TECHNICAL SERVICE BULLETIN

Bulletin Number **08/03**
Issue Date: 26 February, 2003

Subject/Concern: BONNET LATCH ADJUSTMENT

Models: BA Falcon built before December 2002

Figure. 5 and 6 (Bonnet Latch Adjustment)

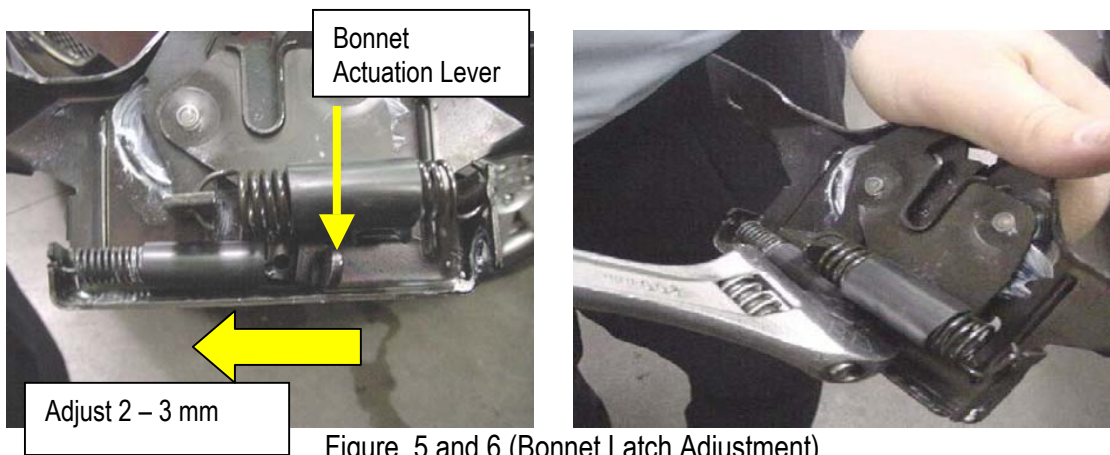
Once the bonnet latch has been removed and cable disconnected adjust the bonnet actuation lever by approximately 2 to 3mm (see Figure 5 and Figure 6)

When adjustment is completed install the bonnet latch and test the travel on bonnet release handle. If the bonnet release handle operates at approximately 50% of travel then adjustment has been completed.
